RIT-T ASSESSMENT: SOUTH AUSTRALIA ENERGY TRANSFORMATION

A FINAL REPORT PREPARED FOR THE AER

Frontier Economics has been engaged by the Australian Energy Regulator (AER) to independently assess the economic analysis and modelling undertaken by ElectraNet in support of its South Australian Energy Transformation (SAET) RIT-T application.

Figure 13: Build cost of pump hydro storage (6 hour)

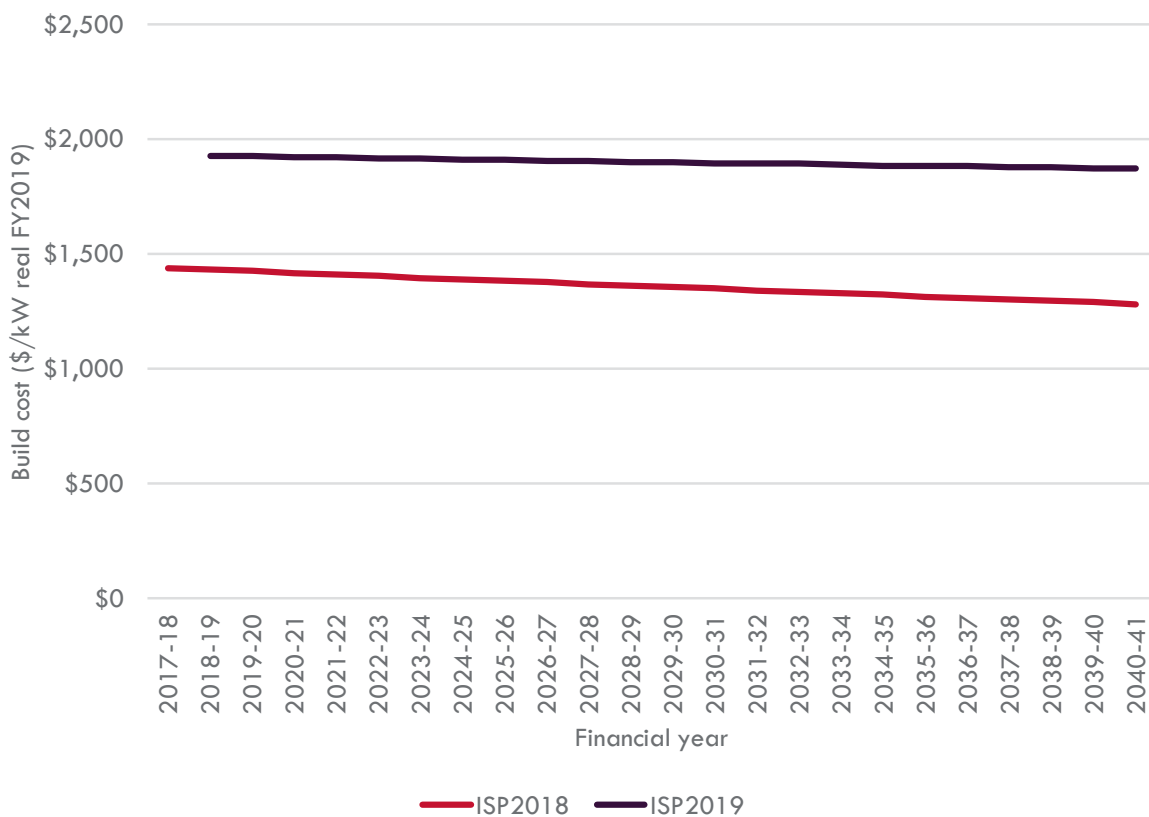
However, the pumped hydro cost assumed by ElectraNet (derived from the ISP) is, in our experience, low for South Australian projects. We note that several reports^{18,19} commissioned by AEMO for the 2019 ISP, have substantially revised AEMO's pumped hydro costs for South Australia. These assumptions are compared in **Figure 13**.

Figure 20: Comparison of key cost drivers in the Base and C3 states of the world, PACR modelling, Central case

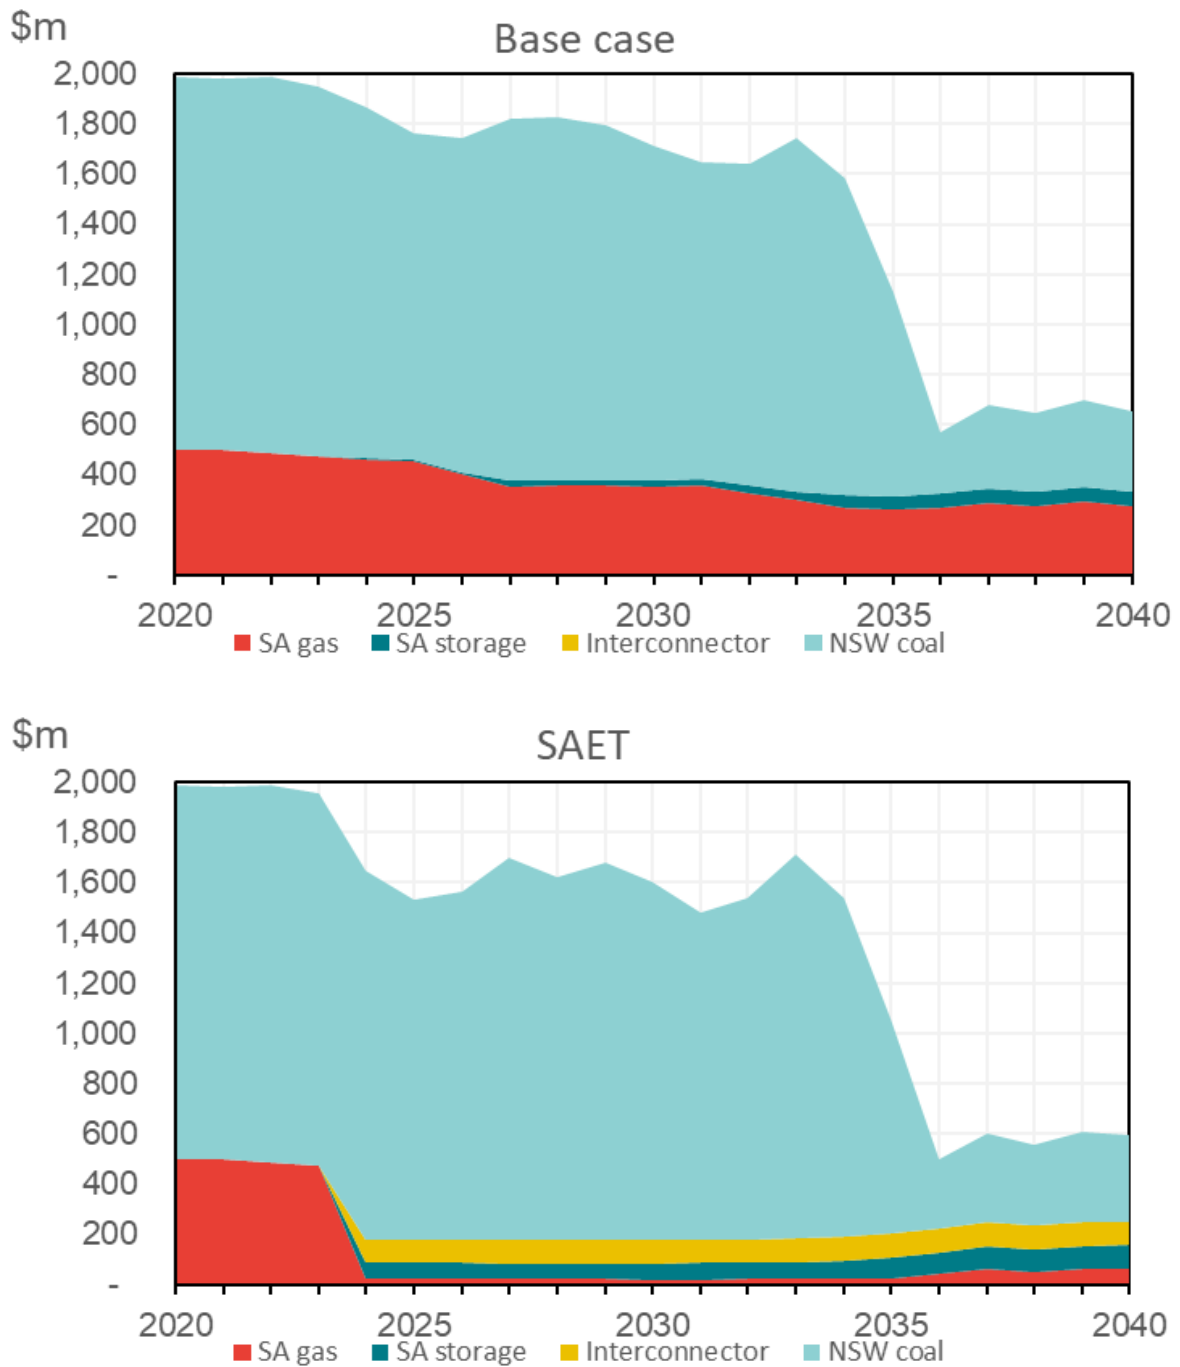
In the first chart in **Figure 20**, the red area reflects the cost of South Australian gas generation, the majority of which is forced on and unavoidable by the model. The second chart shows the difference in the cost of generation once the gas generators are retired and the forced cost is alleviated. This cost is replaced with the cost of the interconnector, shown in yellow, the cost of pumped storage to meet the

reserve margin, shown in dark teal, and an increase in output from black coal, shown in light teal. The net effect of these changes between cases explains the vast majority of the result in the PACR modelling.

Figure 21: Year-on-year differences in generation investment, Base and C3 cases, 'AER Sensitivity 1'

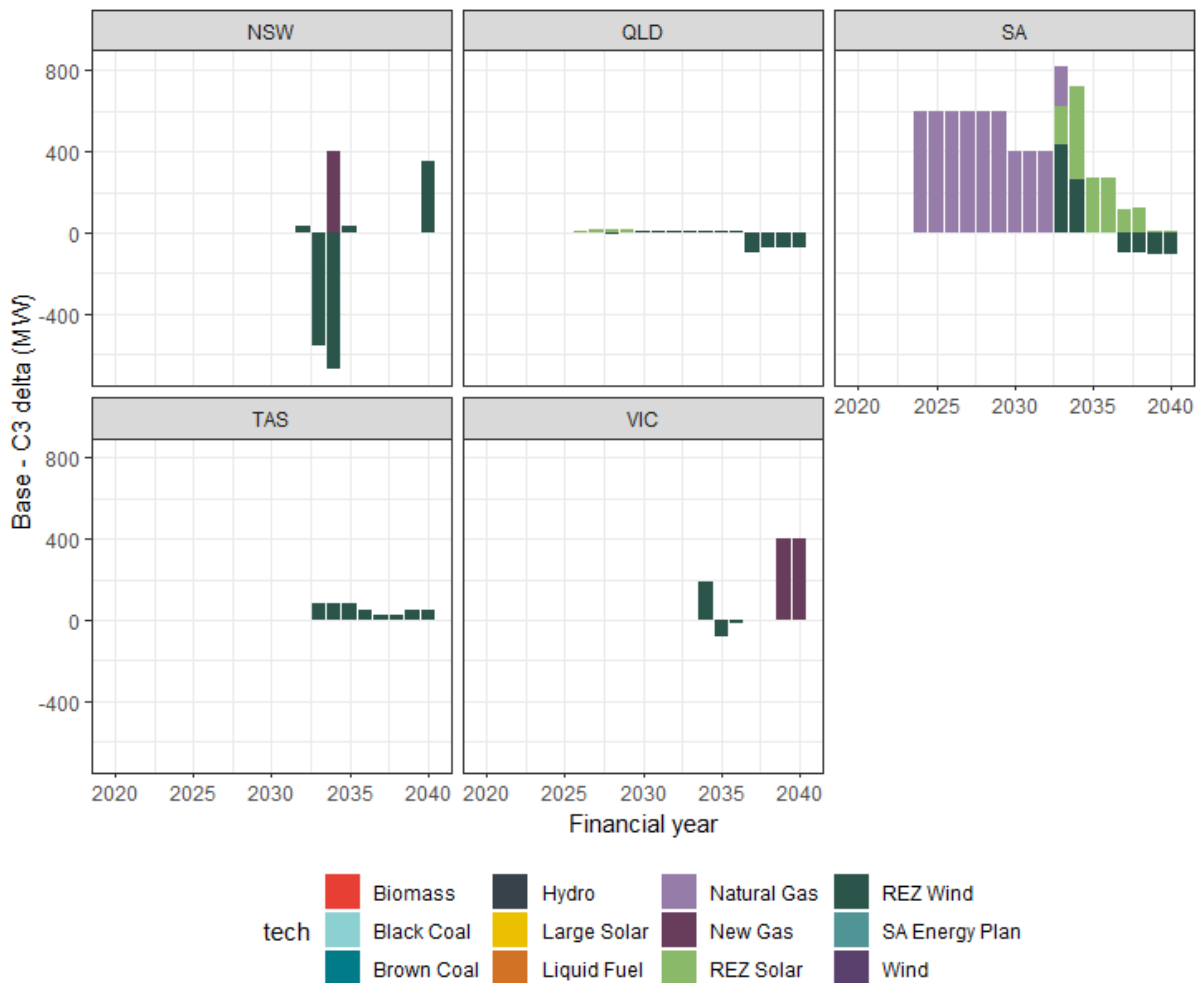
ElectraNet's further modelling presents Base and C3 states of the world that are in closer alignment than they were in the PACR modelling. The key differences in the states of the world, which drive most of the results, are the presence of the interconnector in the C3 state of the world, and the alleviation of the two-unit constraint when the interconnector is commissioned. These cases do not include a number of constraints that were present in the PACR that drove key outcomes, for example the minimum capacity factor assumption on South Australian gas and the exogenous retirements of South Australian gas generators.

The investment results for generation in the Base and C3 states of the world are similar in the further modelling. **Figure 21** presents differences in generation investment results between the Base and C3 states of the world, broken down by region and fuel type. While there are differences in some years in regions outside South Australia, these differences generally do not persist as the overall investment paths between cases do not differ substantially. The main difference is in South Australia, which sees later retirement of Torrens B in the Base case (likely for reserve margin reasons) and investment in solar and wind brought forward more materially than in other regions.

Figure 22: Generation cost differences between the Base and C3 states of the world, ‘AER Sensitivity 1’

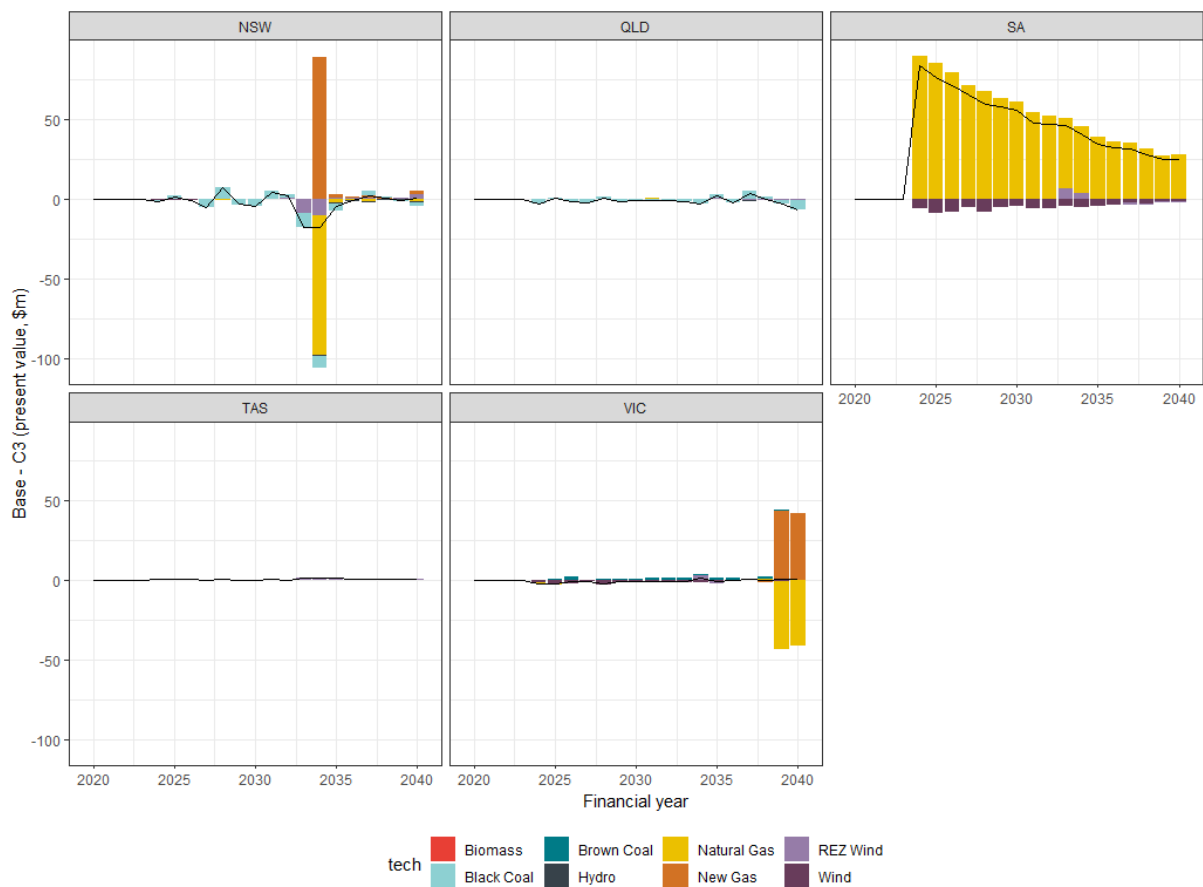
Generation costs between the Base and C3 states of the world are the largest benefit category in the further modelling cost-benefit analysis by a wide margin. Cost differences between the Base and C3 states of the world, in present value terms and broken down by region and fuel type, are illustrated in **Figure 22**. The lines in **Figure 22** represents the net difference between costs in each state of the world. In most regions and most years, the net difference is close to zero, except for South Australia where there is a large and persistent difference in costs of gas generation.

The primary driver of differences in generation costs between the Base state of the world and Option C3 in the further modelling relates to the large volume of output from South Australian gas-fired generation in the Base state of the world. The majority of this gas output is attributable to the two-unit constraint, although the direct cost output is only partially⁵⁰ attributable.

Figure 23: Output differences between the Base and C3 states of the world, ‘AER Sensitivity 1’

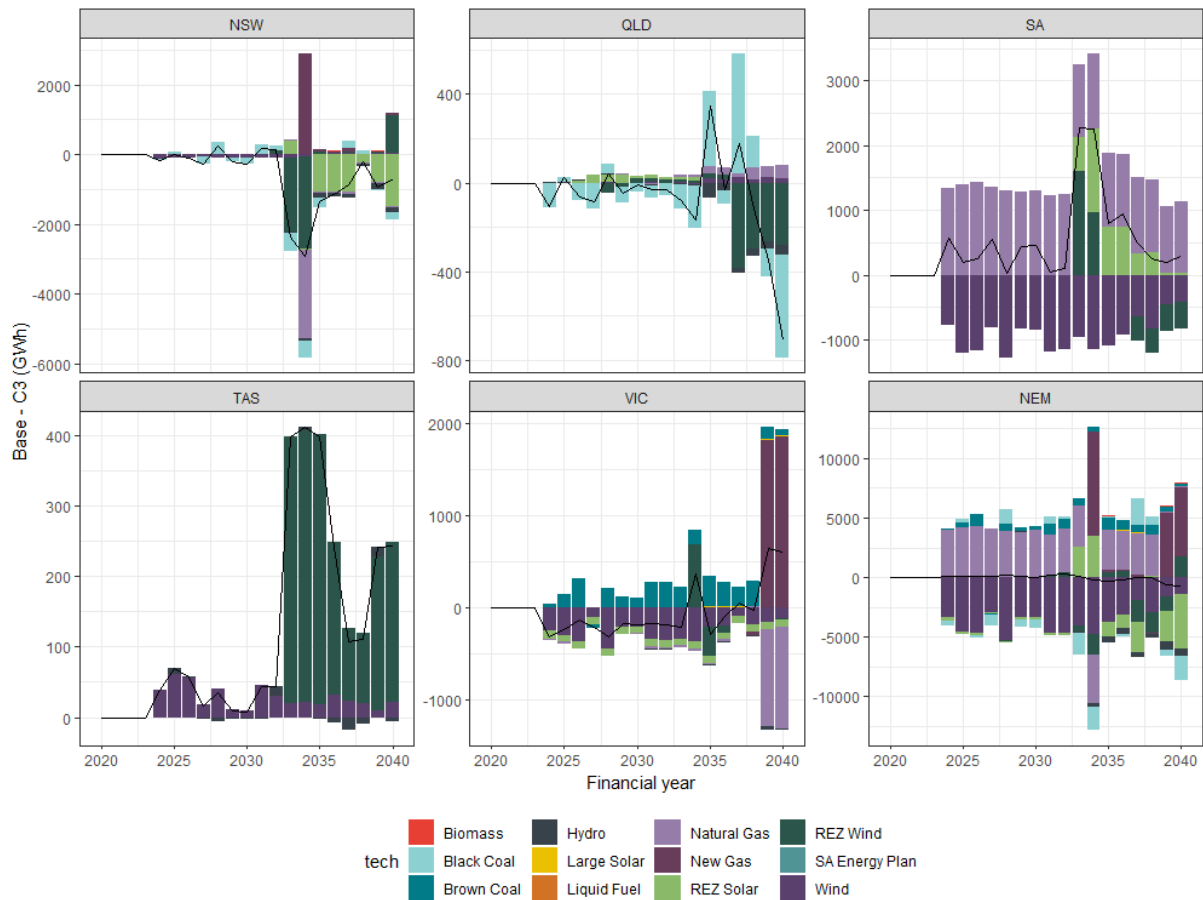
Figure 23 illustrates the difference in output between the base and C3 states of the world, broken down by region (including the whole NEM) and fuel type. The lines in **Figure 23** represent the net difference between costs in each state of the world. While there are differences within and between regions, output in the NEM overall is largely unchanged between the two states of the world as indicated by the flat line around zero in the NEM facet of the chart.

Figure 23 shows that NSW generation output at an annual level is largely unchanged in the presence of the new interconnector until around 2033, nine years after commissioning. The notable output differences presented include the higher level of in South Australian gas in the Base state of the world, and the reduced output from existing wind⁵¹ in South Australia and Victoria. The higher level of South Australian gas is attributable to the two-unit constraint. The reduced output from existing wind is a result of curtailment, discussed in the following section.

Figure 24: Curtailed wind in the Base state of the world, 'AER Sensitivity 1'

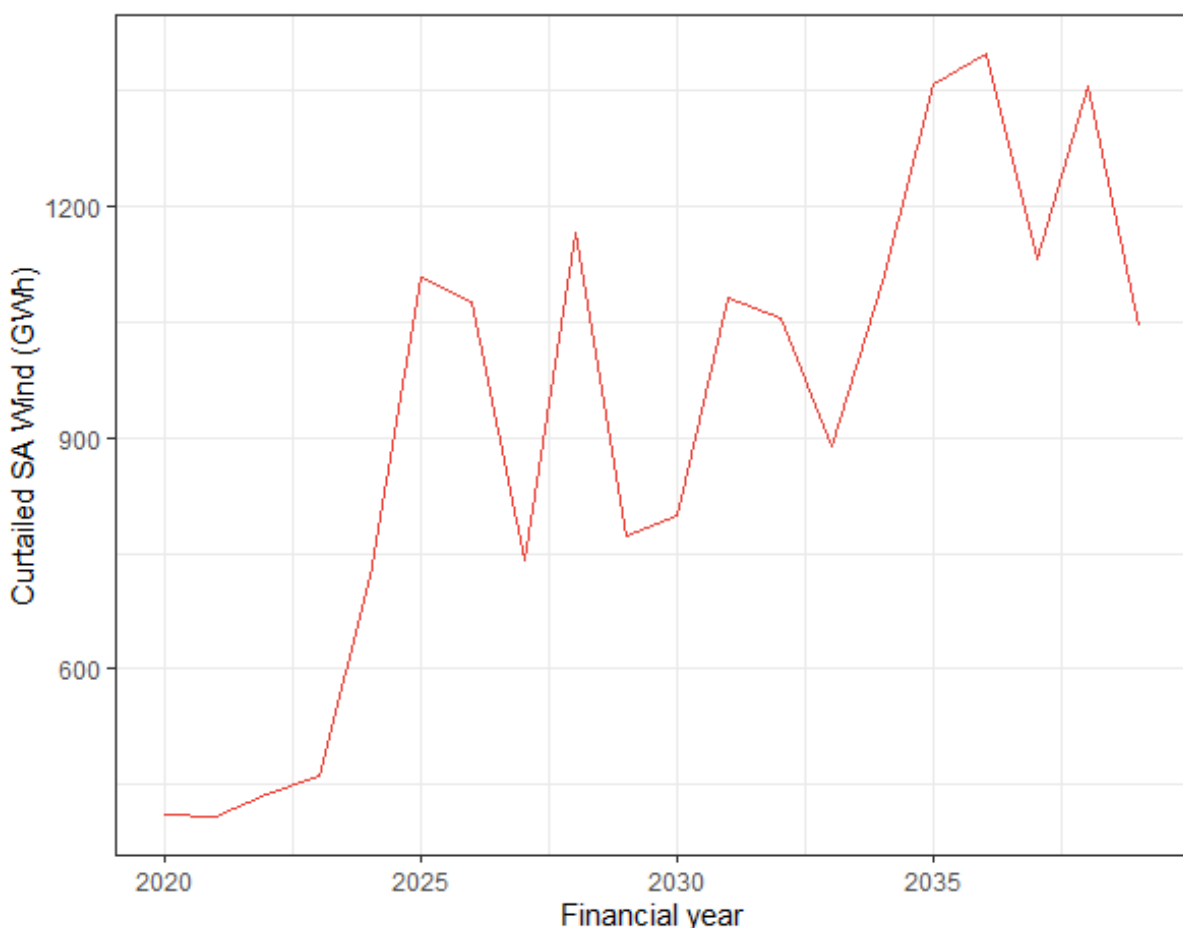
The disconnect between the LT and ST model is also apparent in the shape of prices across the day. In NSW in 2036, for example, the LT model sees price signals of around \$160/MWh on average in the evening, whereas the same investment in the ST model produces outcomes of around \$60/MWh for the same time period. Another example is the impact of solar, which reduces prices in both the ST and LT models during daylight hours. However, the resulting daylight hour prices are higher in the LT model than in the ST model, which means the LT model is likely to invest in solar that does not make sense (e.g. may lead to curtailment) in the ST model.

It appears that inefficient investment caused by this disconnect issue leads to substantial generation curtailment in the further modelling. **Figure 24** illustrates the quantum of curtailed wind in GWh in the Base state of the world. From 2020 to 2023-2024 the magnitude of curtailed wind is in the ballpark of recent historical curtailed wind in South Australia reported by AEMO⁵² at 268GWh for financial year 2018-2019. From 2023-2024, the amount of curtailed wind in the model in South Australia increases from around 400 GWh to between approximately 750 and 1,500 GWh. We noted some curtailment of South Australian wind under Option C3, but not to the same extent, as can be inferred from **Figure 23**.

Figure 25: Curtailment differences in South Australian wind generation between the LT and ST models in the base state of the world, ‘AER Sensitivity 1’

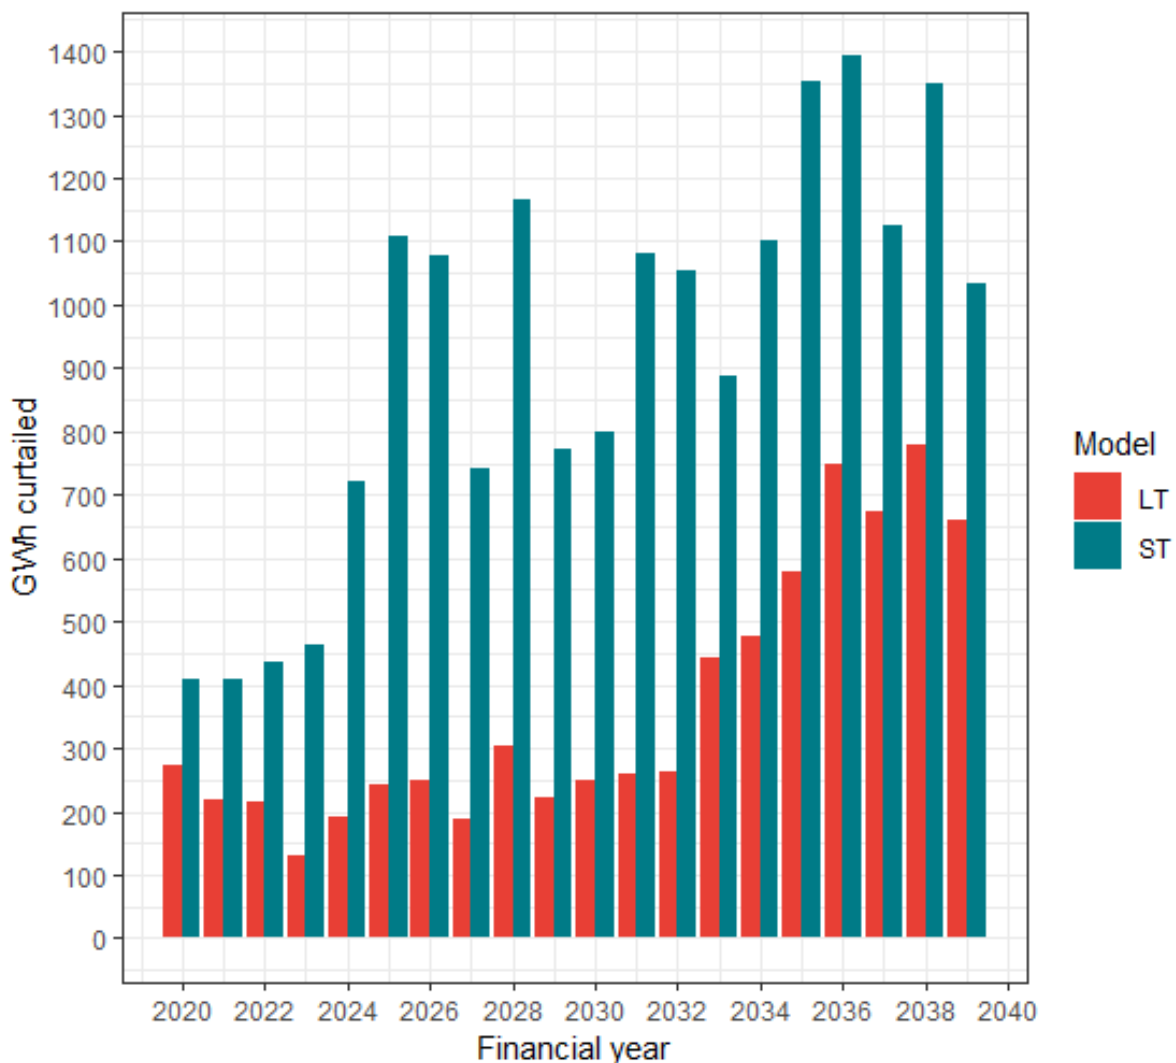
The disconnect between the LT and ST models are evident in comparisons of the amount of wind curtailed in the LT model vs the amount of wind curtailed in the ST model. These differences are illustrated in **Figure 25**.
